Council Reference: DA10/0222.26 LN44549
Your Reference: MP06_0258 MOD 10

Comments on the proposed modification - amendment to Casuarina Town Centre including 56 lot subdivision, road works, infrastructure works and landscaping (Department of Planning Application MP06_0258) MOD 10 at Lot 13 DP 1014470; Casuarina Way CASUARINA; Lot 144 DP 1030322 & Lot 144 DP 1030322 & Lot 3 DP 1042119; Tweed Coast Road CASUARINA

Approved 20m Easement

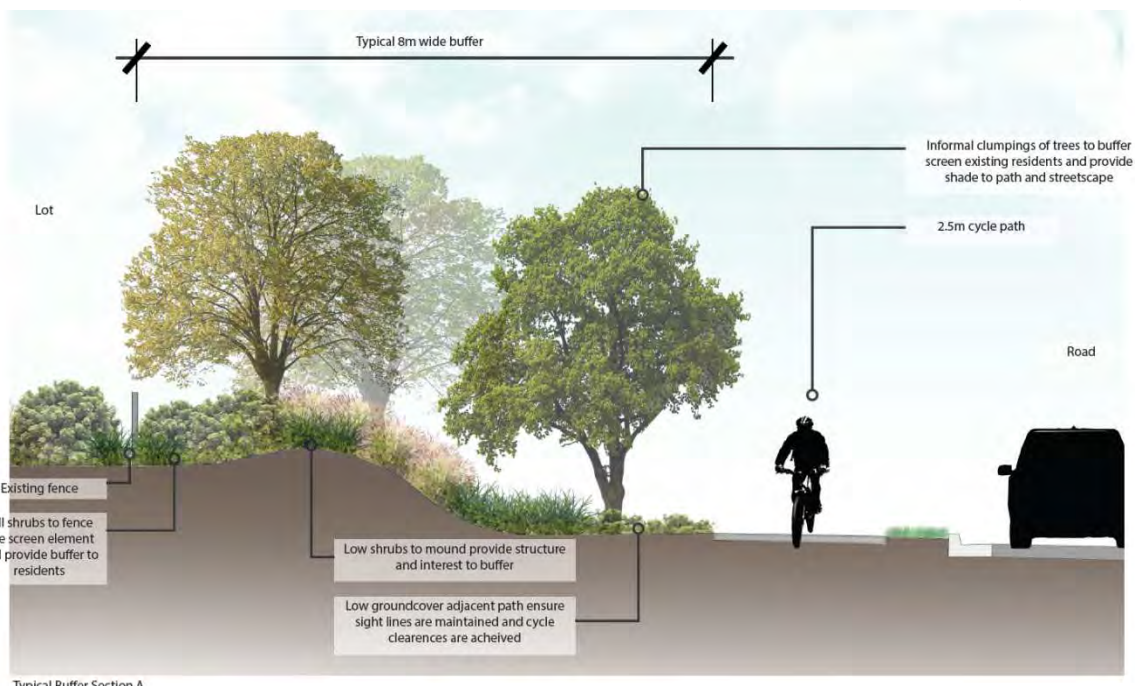
In granting owner's consent for works to be carried out in this area, Council agreed to relinquish the 36m wide easement in return for the dedication of the 20m wide

drainage reserve. To date these works and dedication have not taken place. The previously approved 20m easement is demonstrated below;

It is now proposed to locate a road within this 20m dedication, resulting in a reduced 8m wide buffer, as identified in the subdivision layout and below;

Footpaths / Cycleway

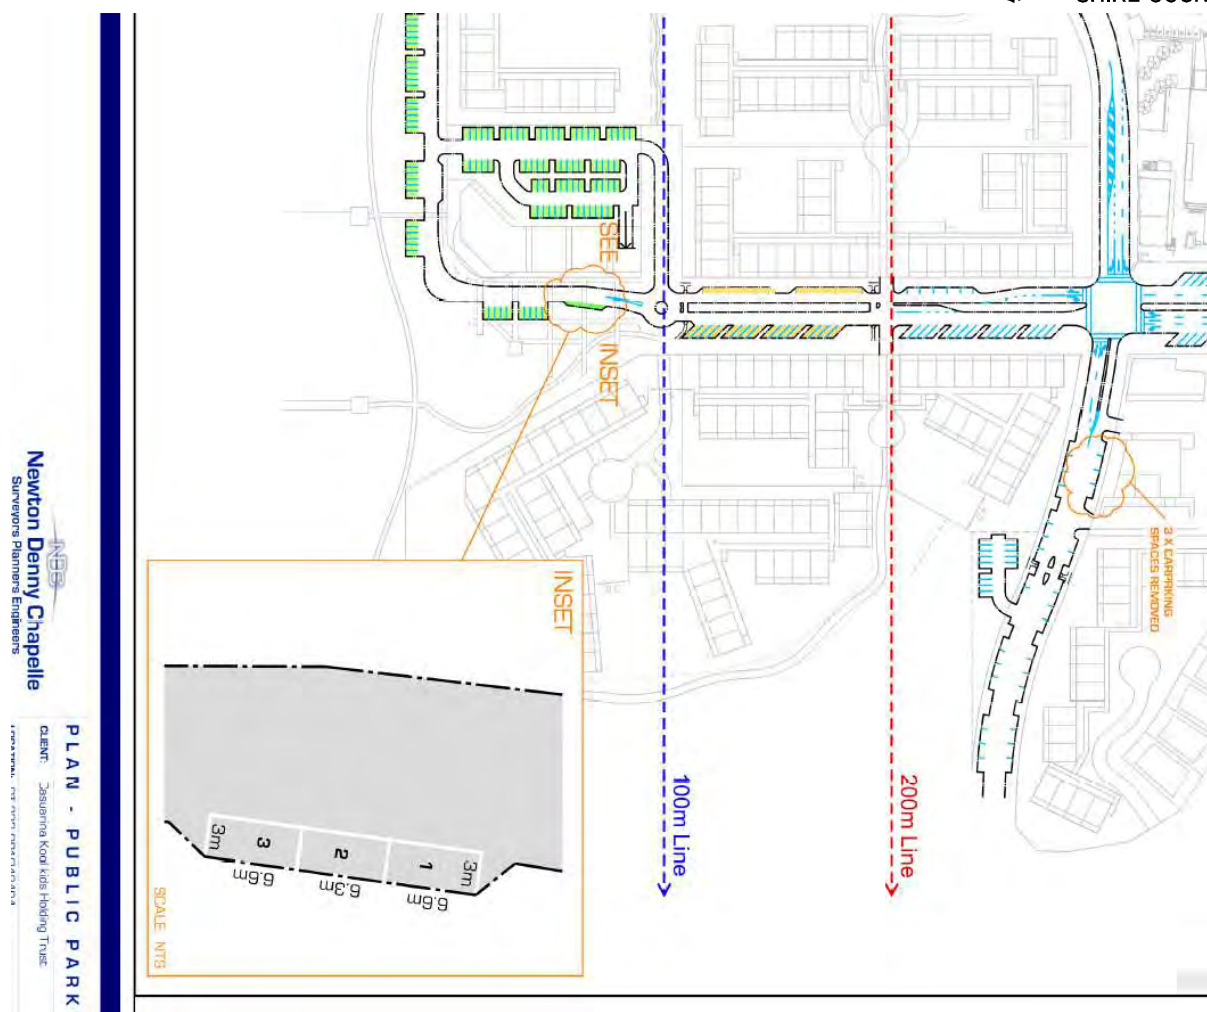
- The existing approval includes a proposed 3.5m wide cycleway connecting from Casuarina Way to Casuarina foreshore along an easement of various widths. In addition the approval provides an additional cycleway connection to Casuarina Way near the existing Santi building.

The proposed modification now seeks to reduce the proposed cycleway width from 3.5m to 2.5m and delete the additional cycleway connection to Casuarina Way near the existing Santi building. The cycleway width of 3.5m and cycleway connection to Casuarina Way near the existing Santi building is to remain as per approved.

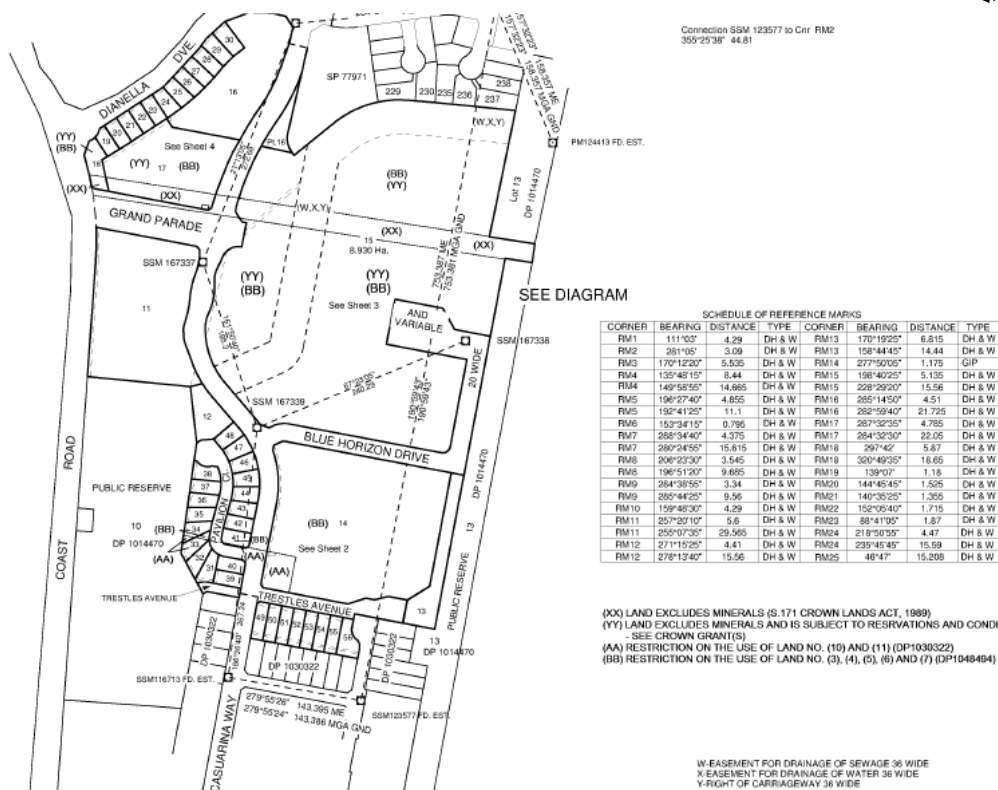
Of relevance to this assessment is a letter dated 24 September 2013 to NDC from Council's Coordinator Development Engineering. This provides a summarised history of the issues, and in consideration of the proposal to fill and pipe the swale and reduce the easement width concludes:

- *"Council wishes to retain the existing approval drainage reserve to ensure a minimum urban buffer is achieved. Therefore, Council does not accept piping of the whole open drain and the reduction of drainage reserve widths and easement widths from the original agreement."*

The current proposal does not acknowledge this previous advice, or attempt to address the urban design issues associated with the proposed changes to the easement and associated works. As such, there is no justification for Council to change the viewpoint of opposing piping of the whole swale, and no changes to the existing easement benefiting Council will be supported.
